PROJECT: WSISD - New Maintenance and Operations Warehouse 24-103.00      DATE: 5/30/2025

SUBJECT: 24-103.00 - New Maintenance and Operations Warehouse - Addendum 01      TRANSMITTAL ID: 00006

ADDENDU NO. 1 TO THE DRAWING  
FOR  
**NEW MAINTENANCE AND OPERATIONS WAREHOUSE**  
**WHITE SETTLEMENT ISD**  
**WHITE SETTLEMENT, TEXAS**

A4.01

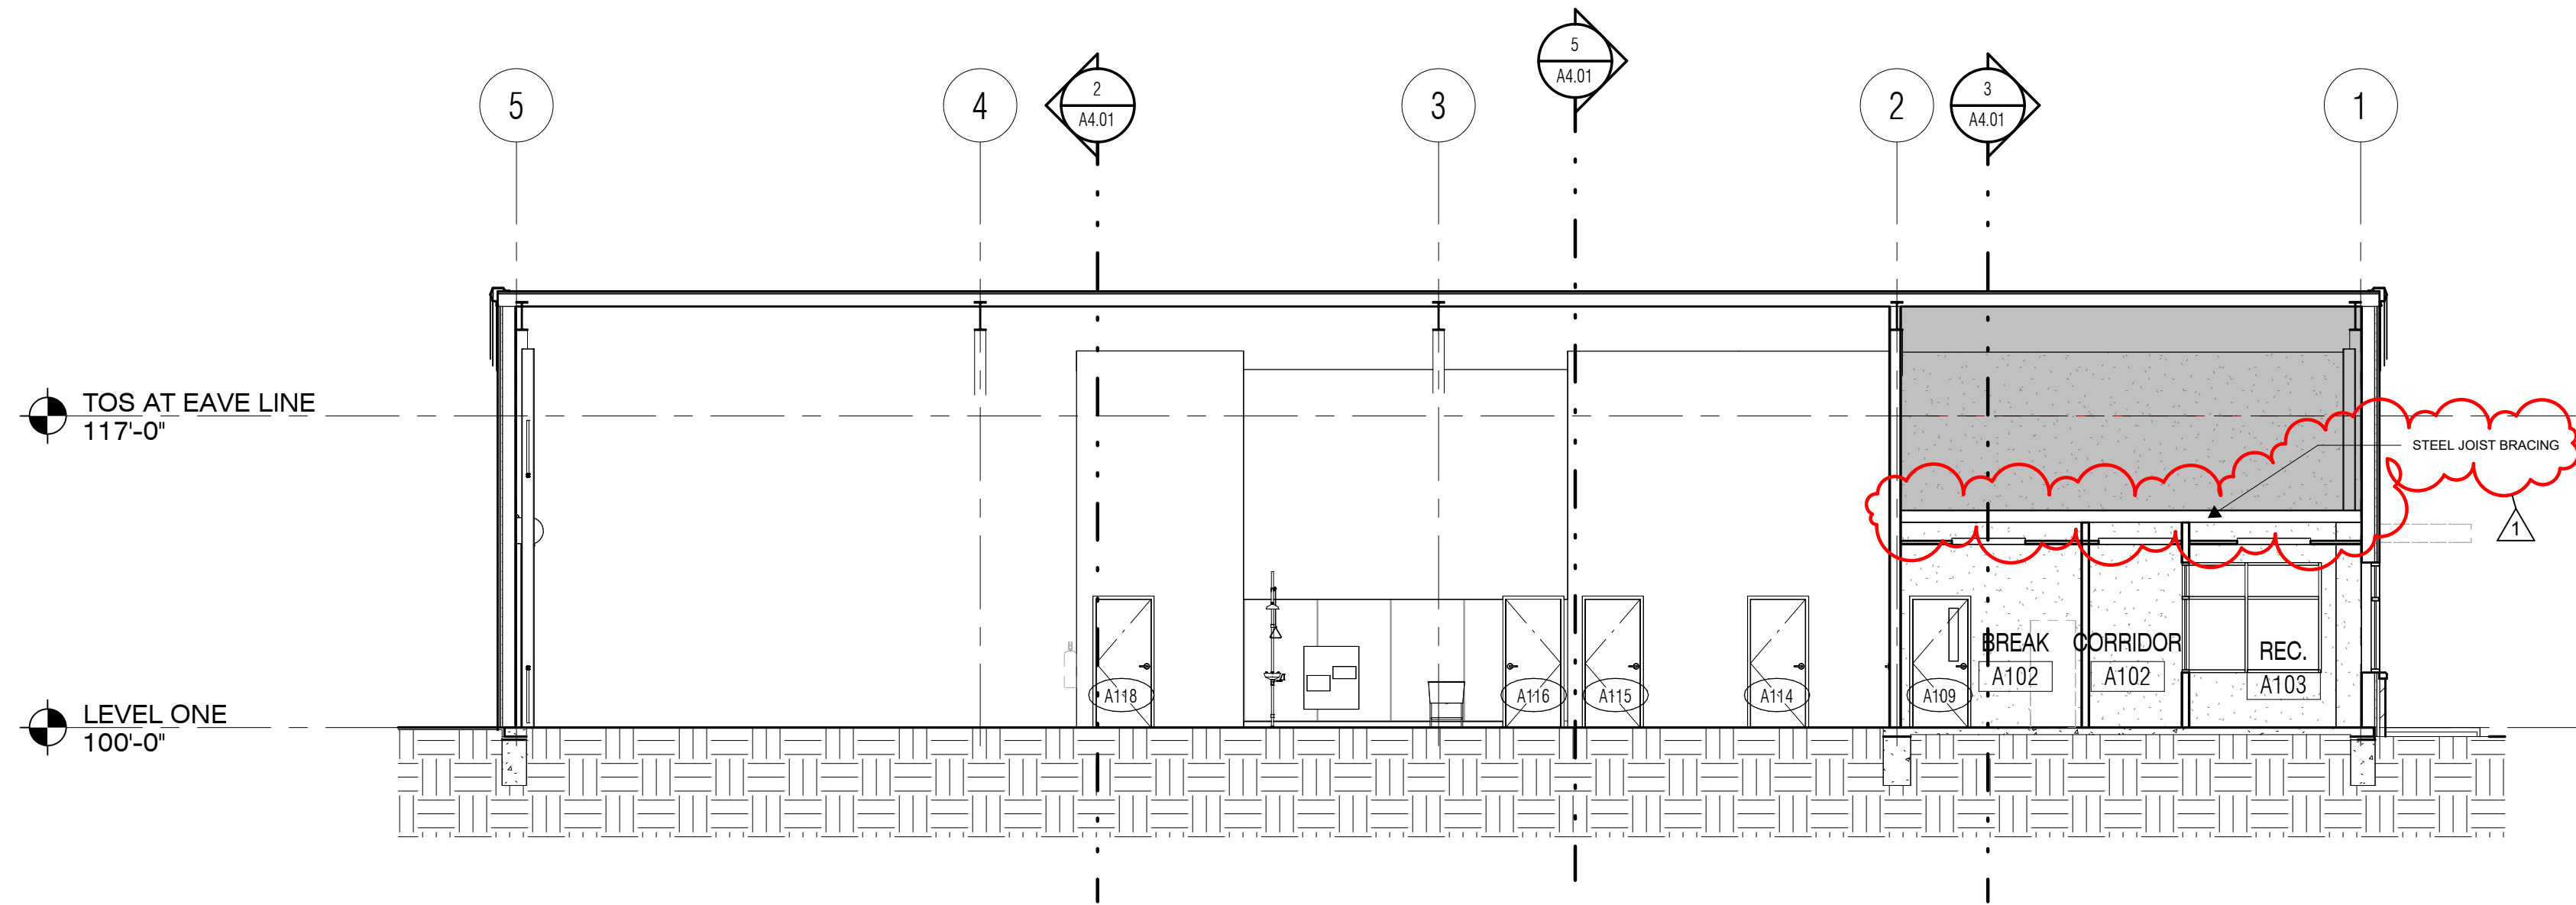
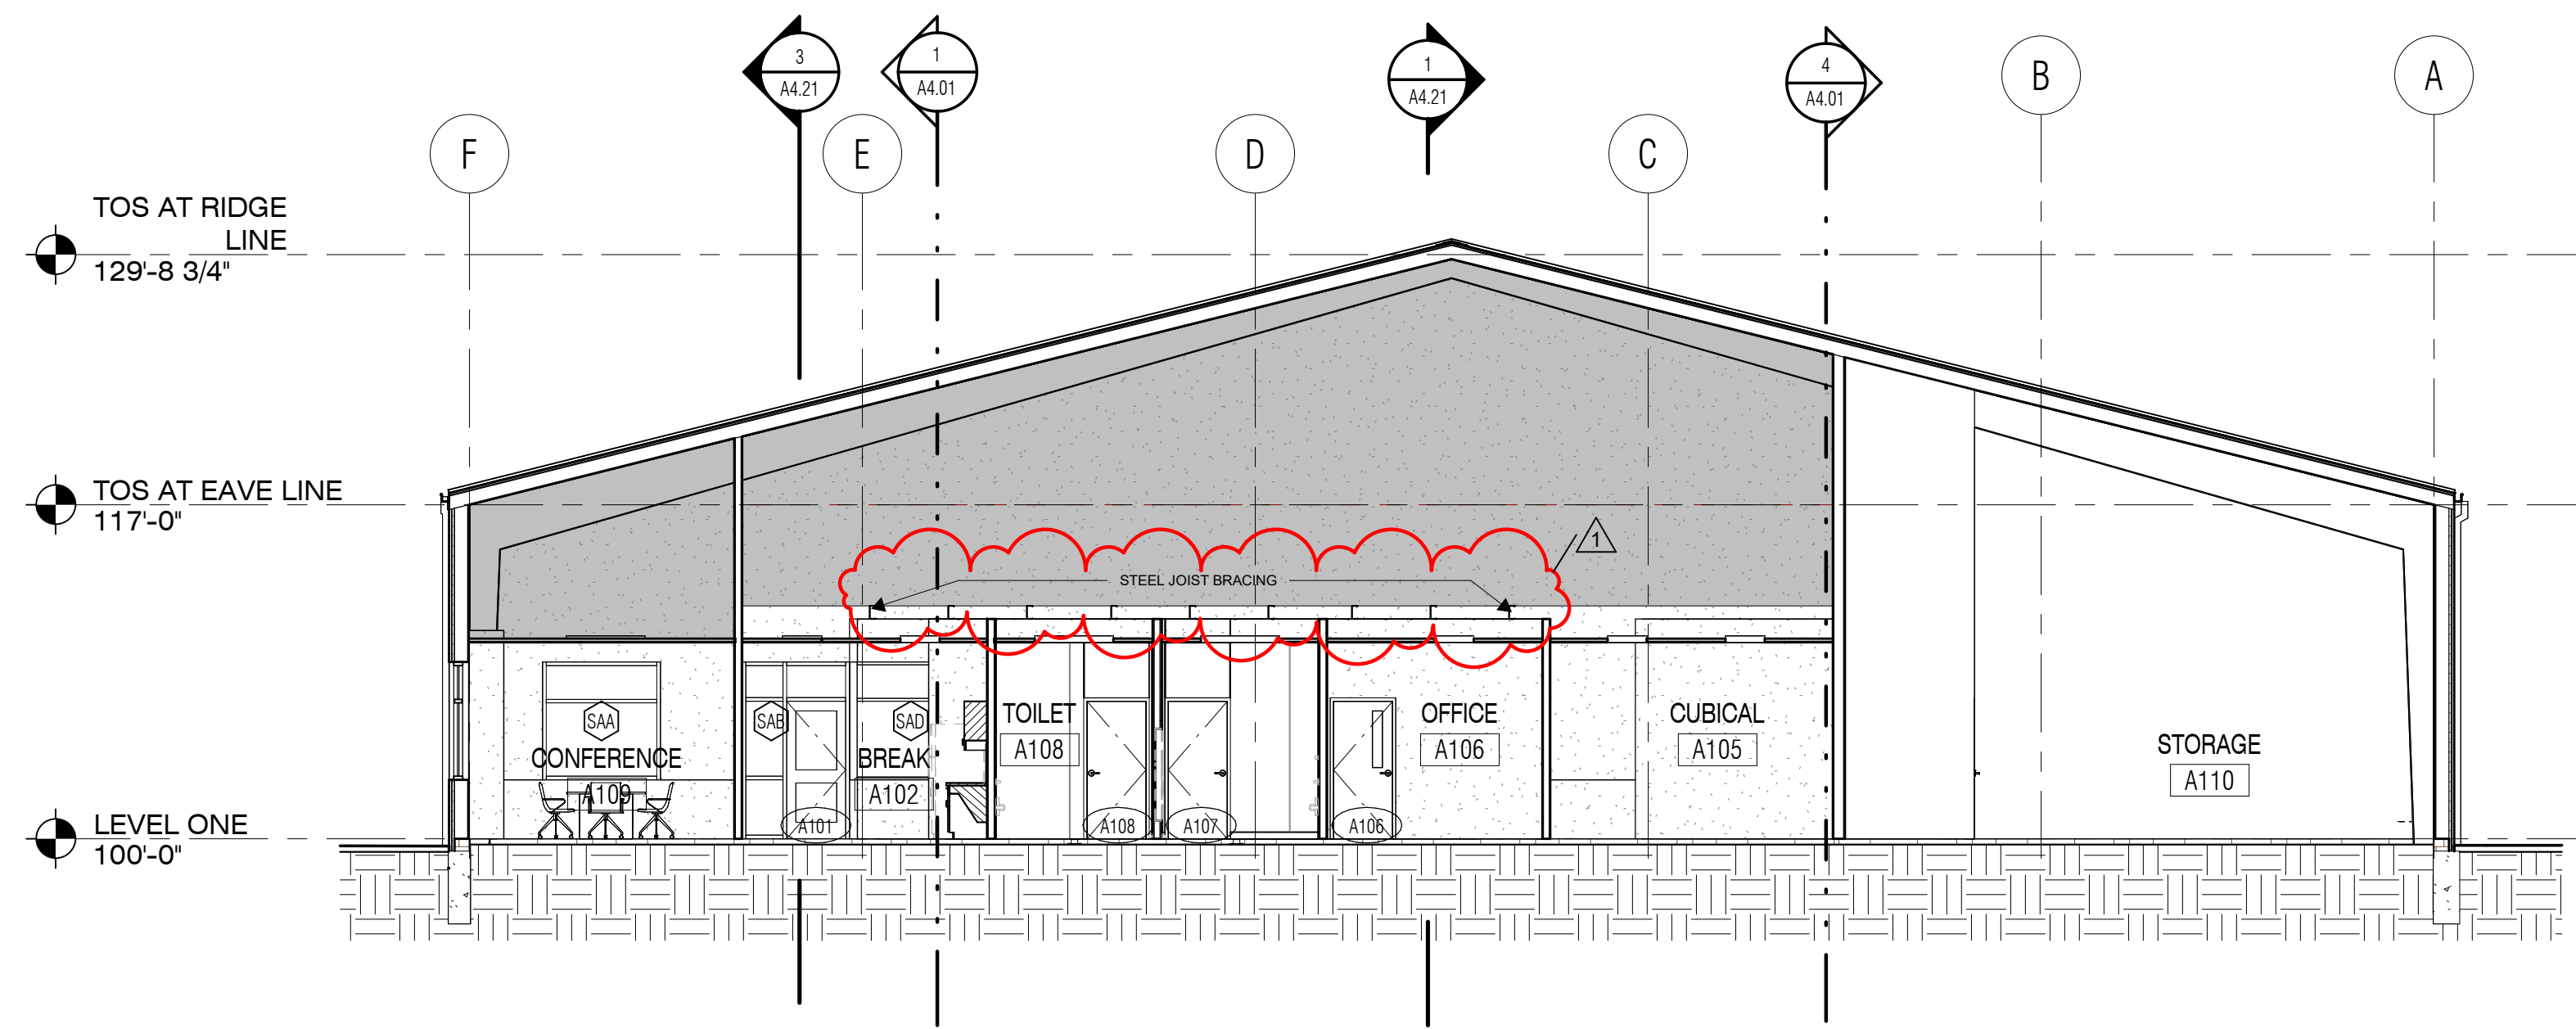
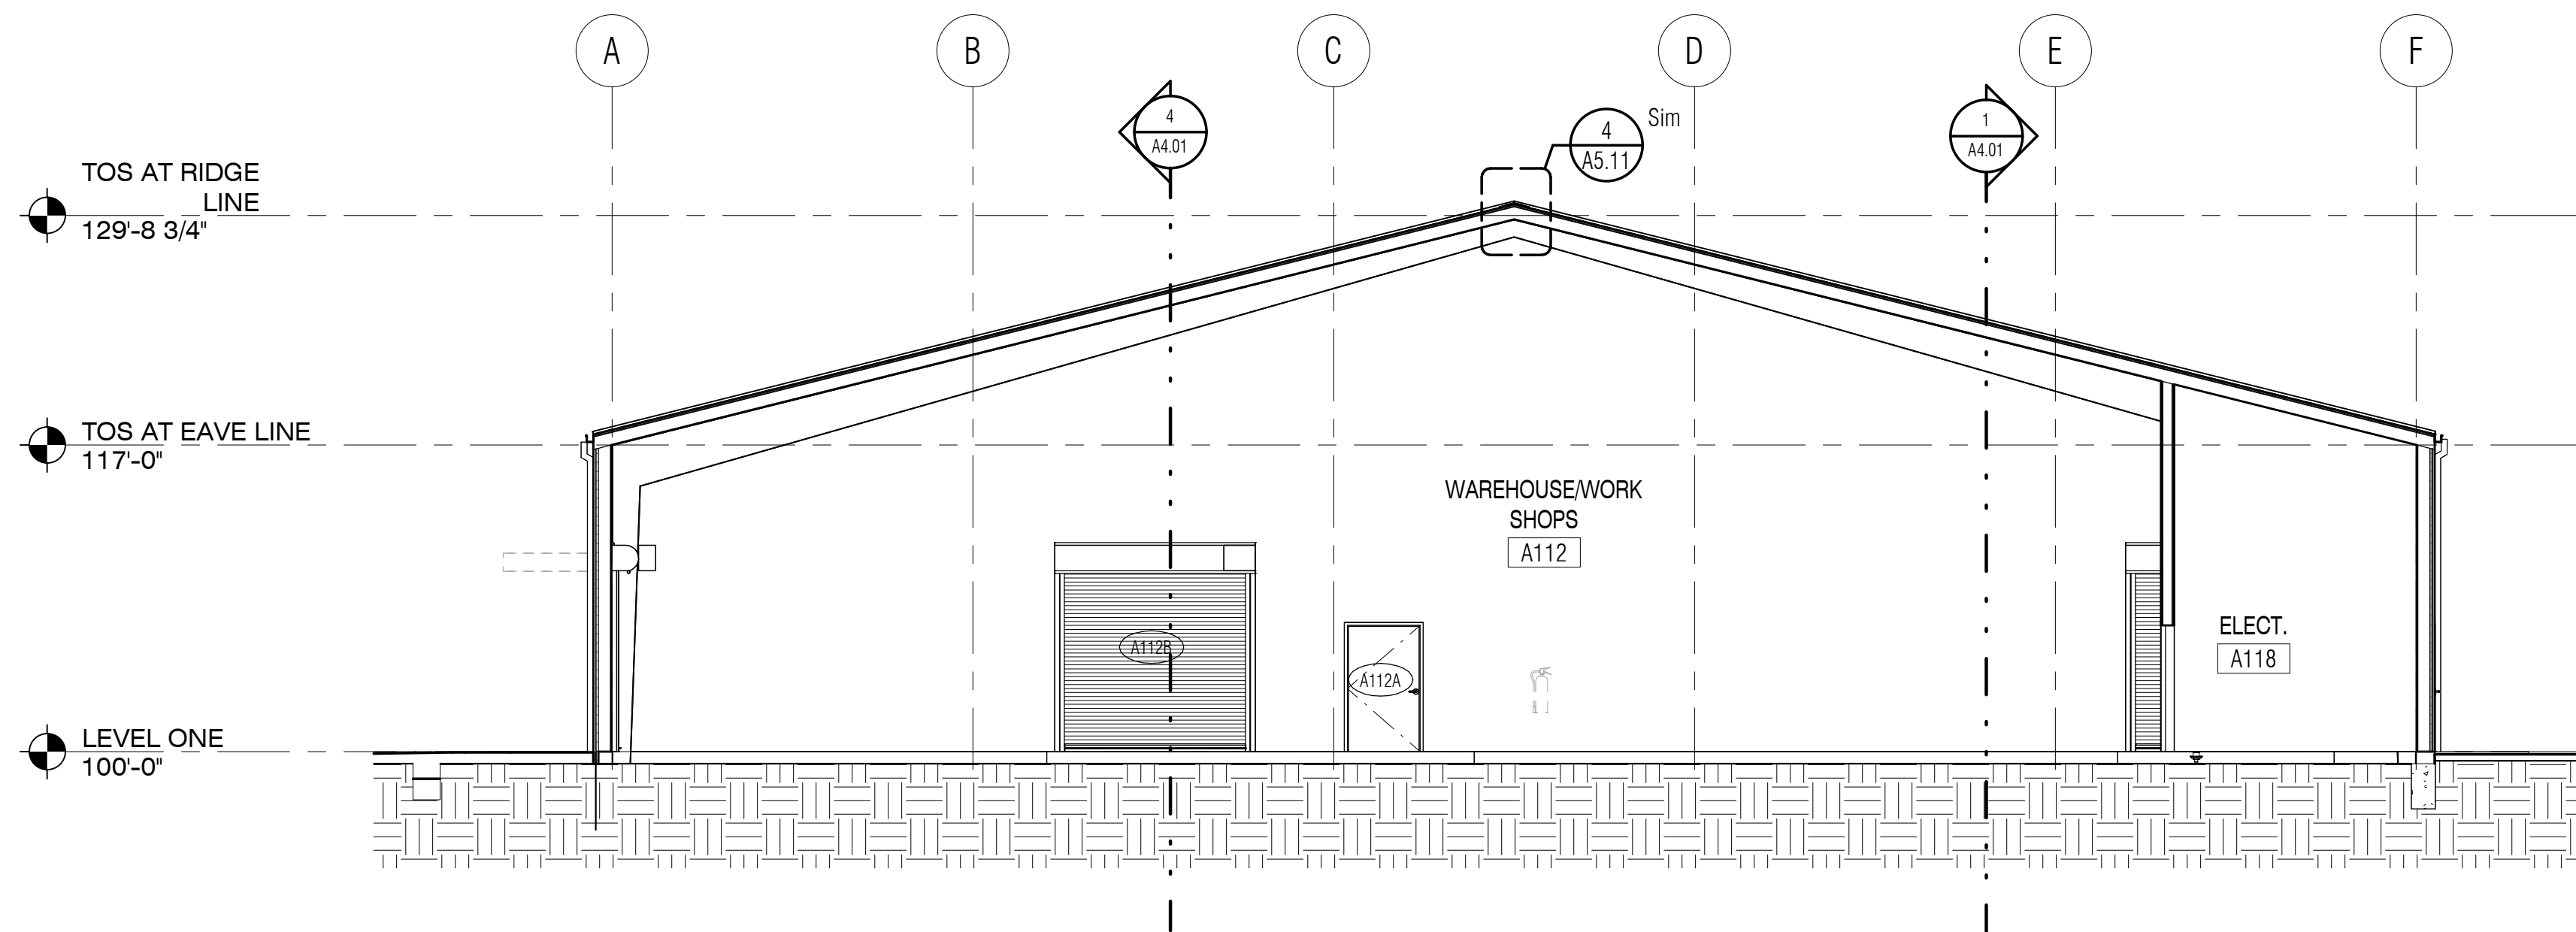
**1.5 SHEET A4.01 BUILDING SECTIONS**

- A. Steel Channel joist bracing added above ceiling to brace wall at back of house.
